ADDENDUM
NO. 1

July 16, 2020

Additions & Renovations to Lawrence North High School
7802 Hague Road
Indianapolis, IN 46256

PREPARED BY SCHMIDT ASSOCIATES FOR:
LAWRENCE NORTH HIGH SCHOOL RENOVATION
LAWRENCE TOWNSHIP, M.S.D. OF

J. **Drawing Number EL1K1.**

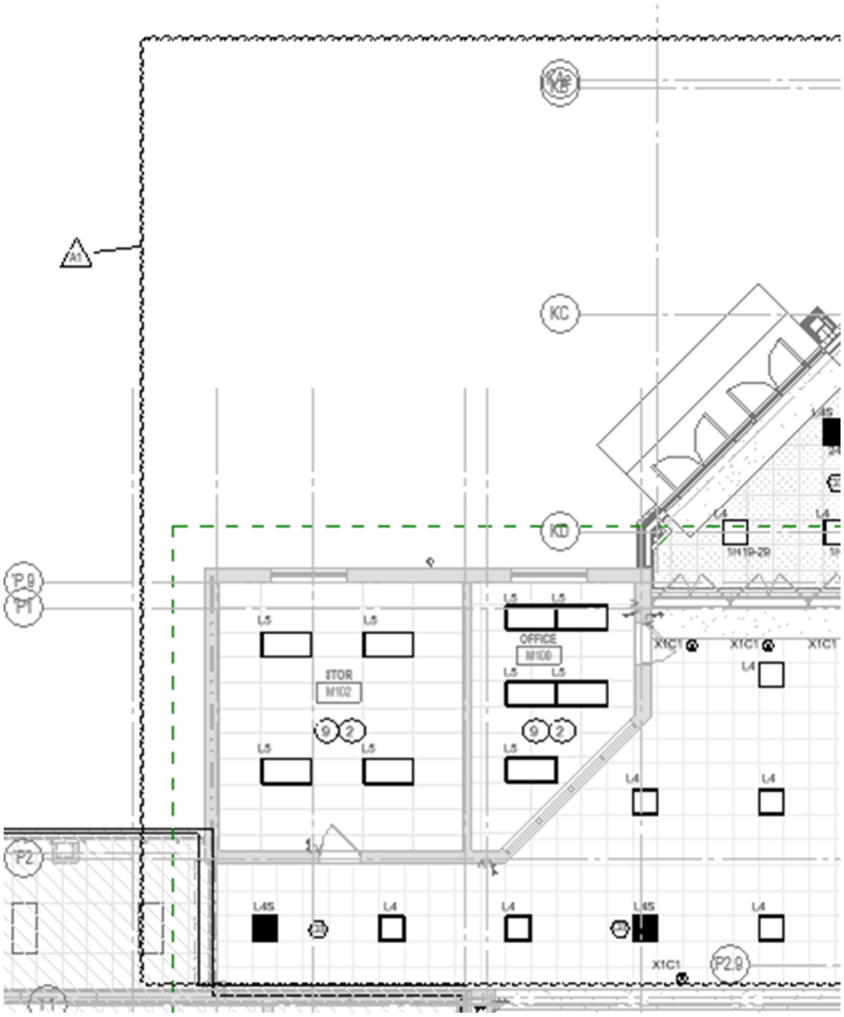
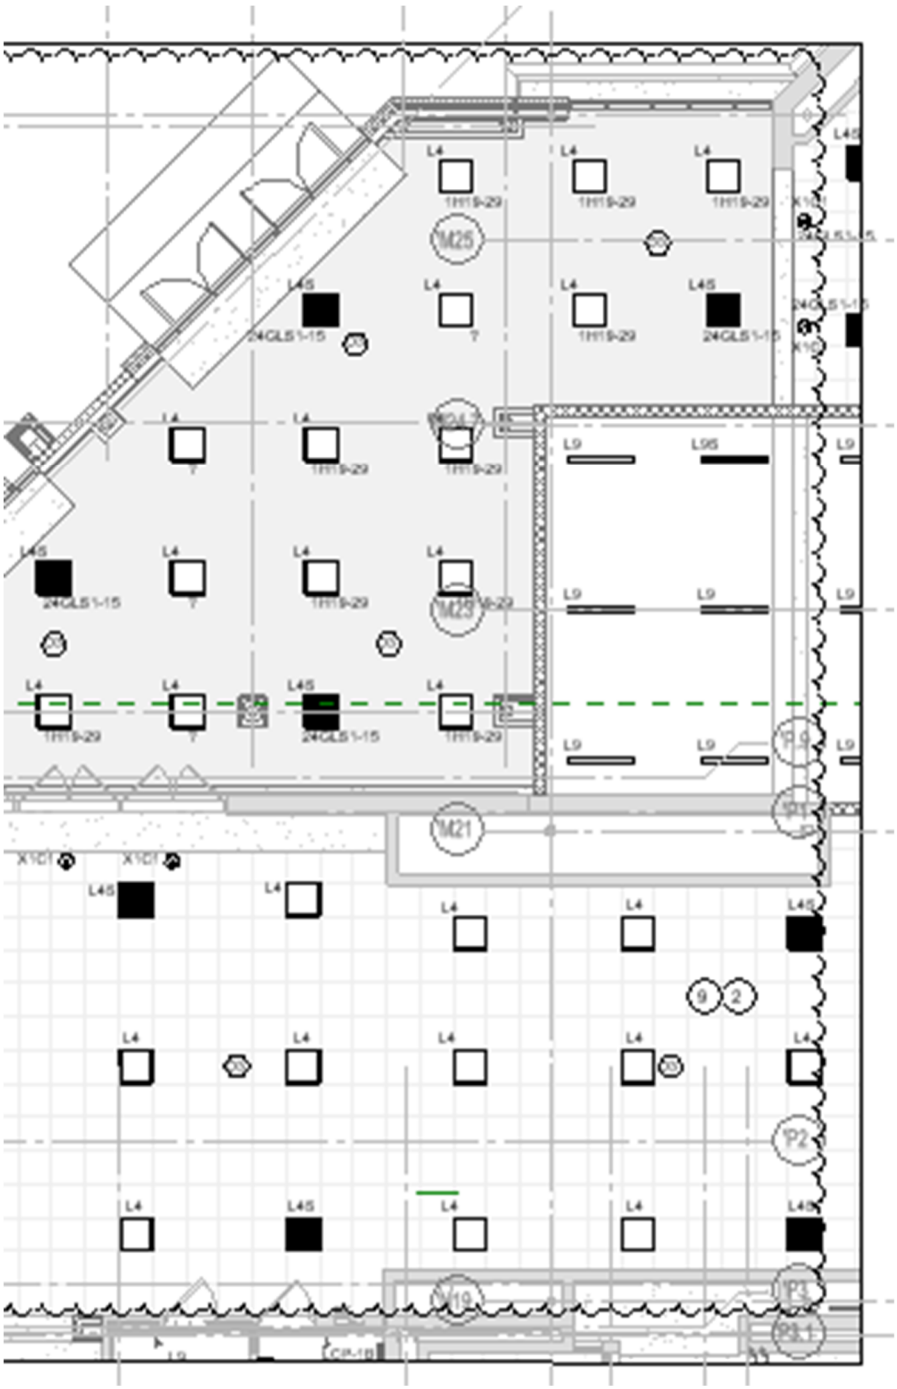
1. ADD Partial Plan to Unit K as follows:

K. **Drawing Number EP1K1.**

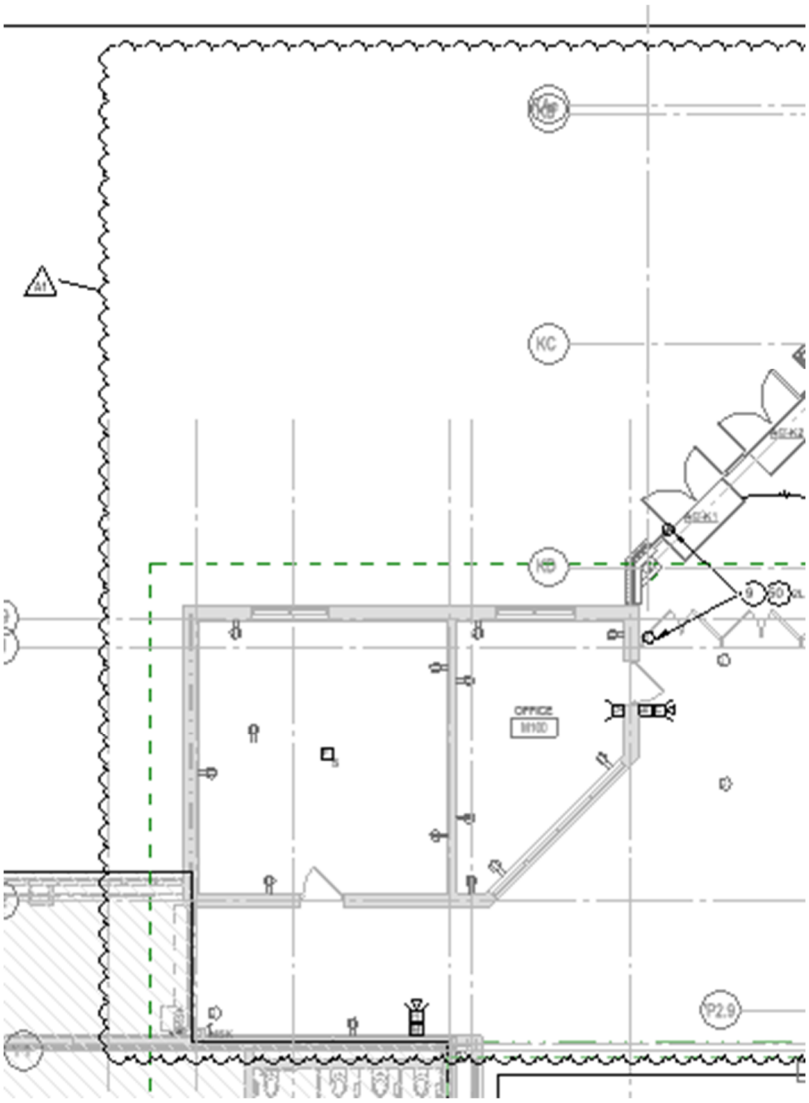
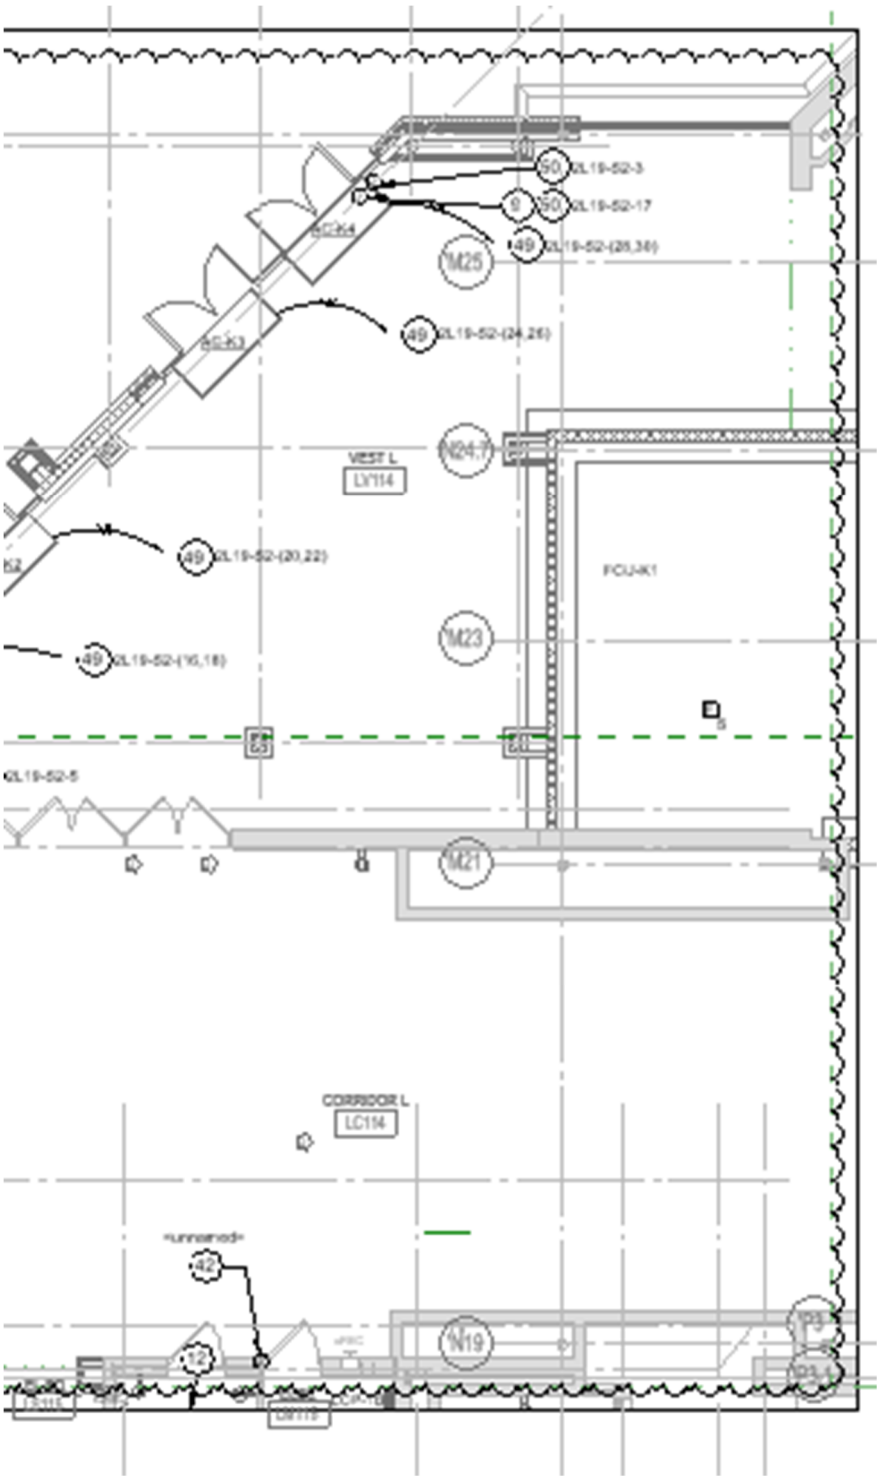
1. ADD Partial Plan to Unit K as follows:

P. **Drawing Number EP1D1.**

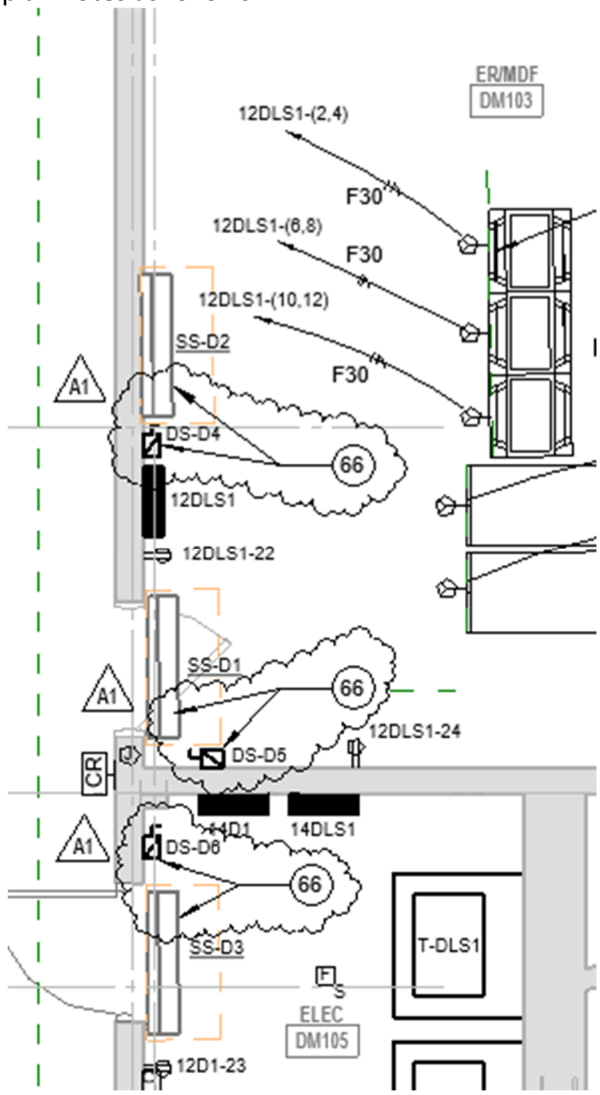
3. In DM103 and DM105, at SS-D1, SS-D2, and SS-D3, add fused disconnect switches and plan notes as follows:

R. **Drawing Number EP1F1.**

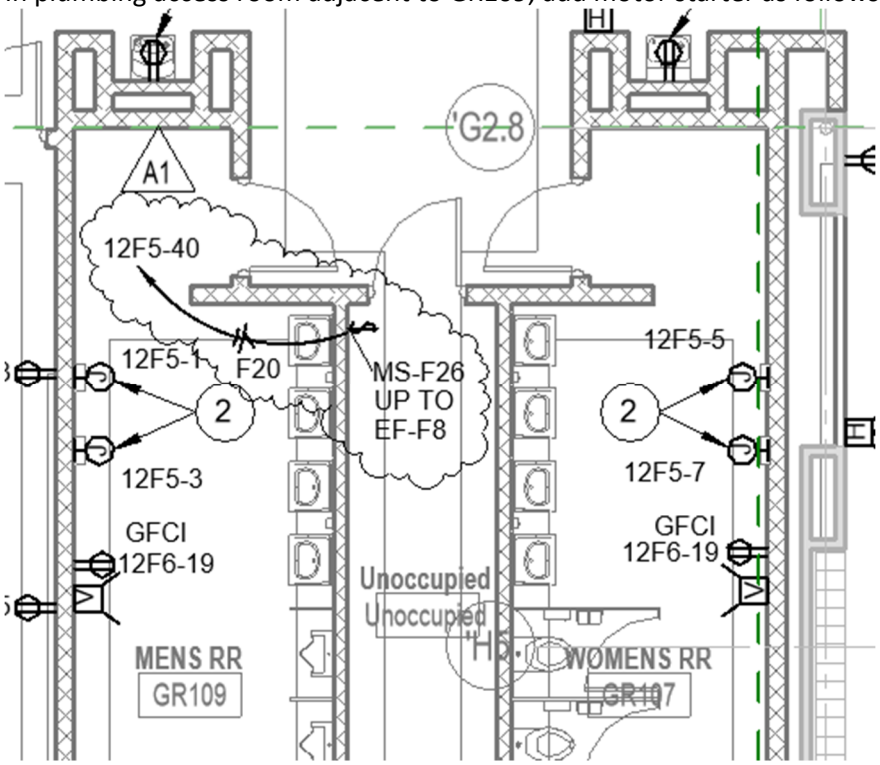
1. In plumbing access room adjacent to GR109, add motor starter as follows:

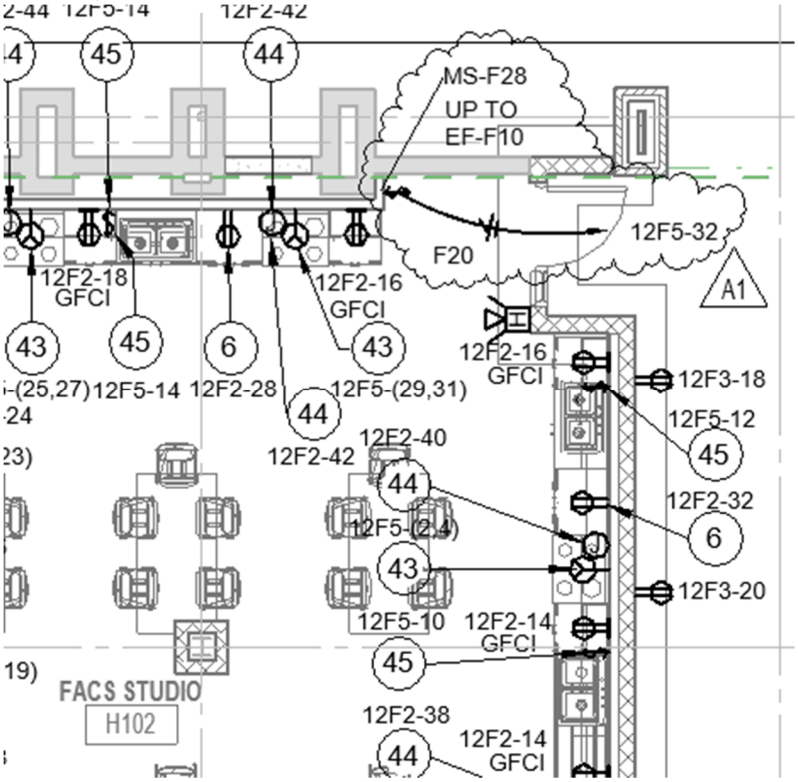
5. In H102, add motor starter as follows:

X. **Drawing Number E-401.**

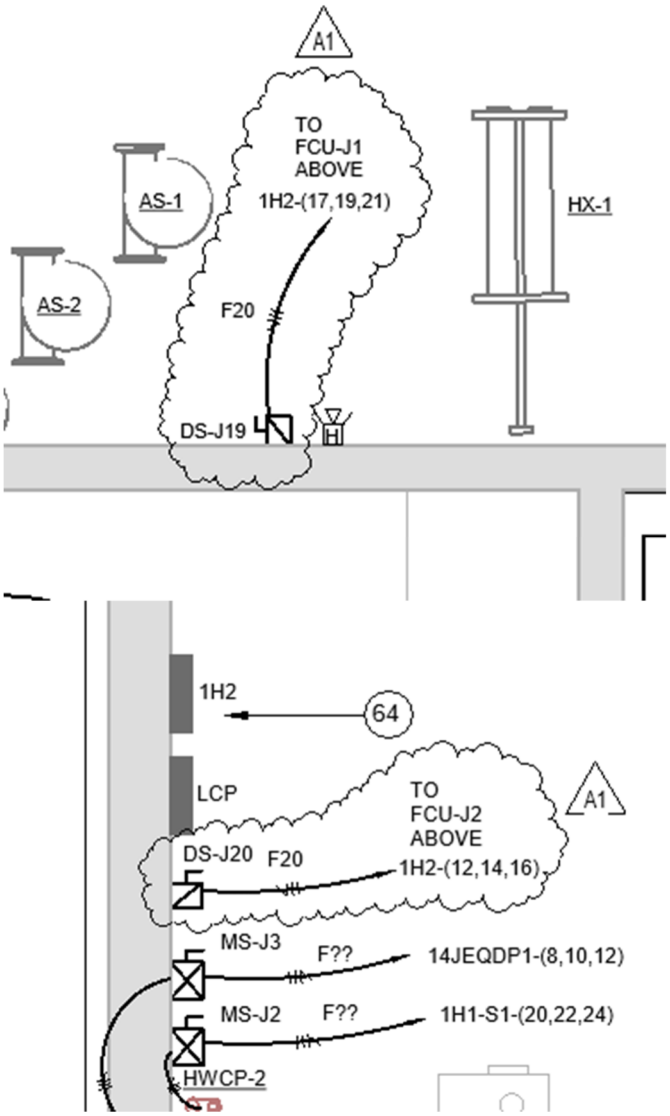
1. On 1A Main Elec/Mech – Enlarged Power Plan, add fused disconnects and circuits for FCU-J1 and FCU-J2 as follows:

Y. **Drawing Number ER101.**

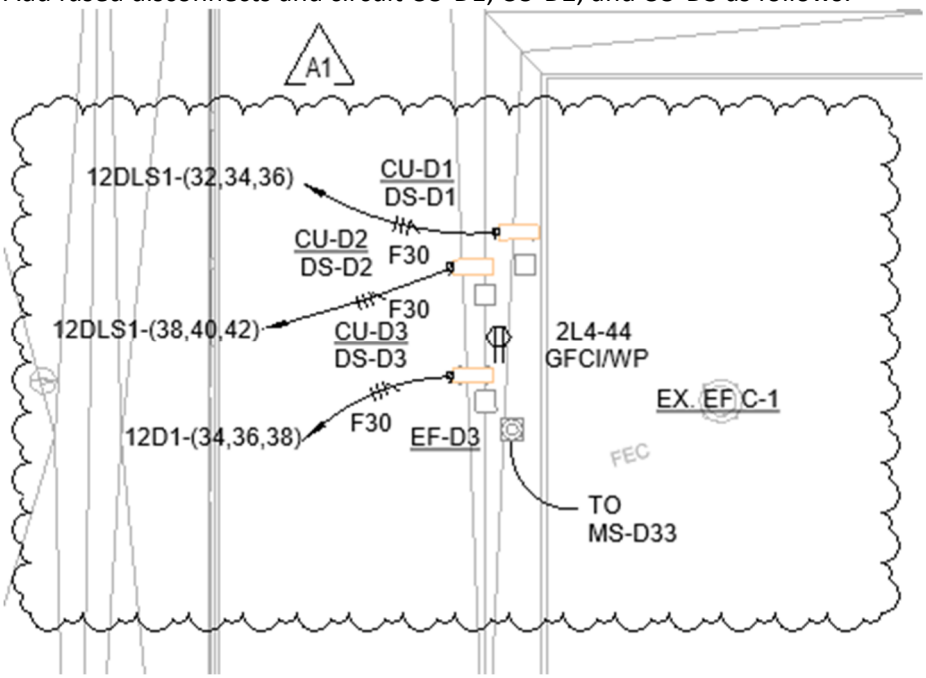
8. Add fused disconnects and circuit CU-D1, CU-D2, and CU-D3 as follows:
